GROUP	MODEL
<b>Voluntary Service Campaign</b>	<b>2024MY Telluride (ON)</b>
NUMBER	DATE
<b>SC344</b>	<b>July 2025</b>

### SMART CRUISE CONTROL SOFTWARE LOGIC IMPROVEMENT (SC344)

This bulletin provides information to upgrade the Smart Cruise Control (SCC) system software on 2024MY Telluride (ON) vehicles produced from May 16, 2023 through September 10, 2024. Due to radar signal interference in certain roadway conditions, the subject vehicles may unnecessarily and momentarily reduce speed when SCC is engaged, accompanied by the illumination of a "Collision Warning" message in the instrument cluster, a warning sound, as well as the activation of the vehicle's brake lights. After the warnings cease, the vehicle will accelerate normally to the SCC set speed. Dealers will upgrade the software logic of the front radar (FR\_RADAR) system to prevent unnecessary reduction in vehicle speed. Refer to [SST081](#) for software upgrade instructions using Kia Diagnostic System (KDS) tablet and VCI-II and confirm the Upgrade Event Number/Name, ROM ID Information, and Manual Mode passwords (if applicable) on the applicable vehicle. Before conducting the procedure, verify that the vehicle is include

**ROM ID Information Table:**

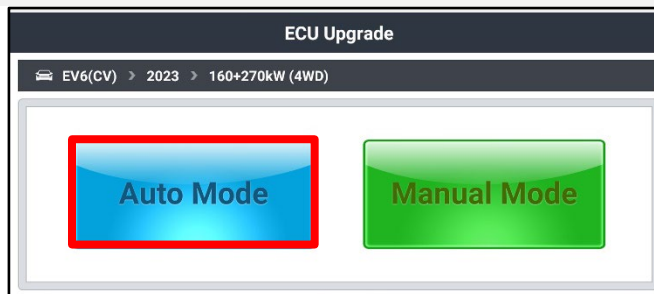
It is recommended to ALWAYS check the Electronic Parts Catalog (EPC) to locate the ECU Part Number respective to Auto/Manual Mode ROM IDs. DO NOT reference the parts label affixed to the ECU.

To verify the vehicle is affected, be sure to check the Calibration Identification of the vehicle's ECM ROM ID and reference the Information Table as necessary.

Model	System	IMMO 	ECU P/No.	ROM ID	
				Previous	New
ON	FR_RADAR	Yes	99110 S9160	1.00	1.01
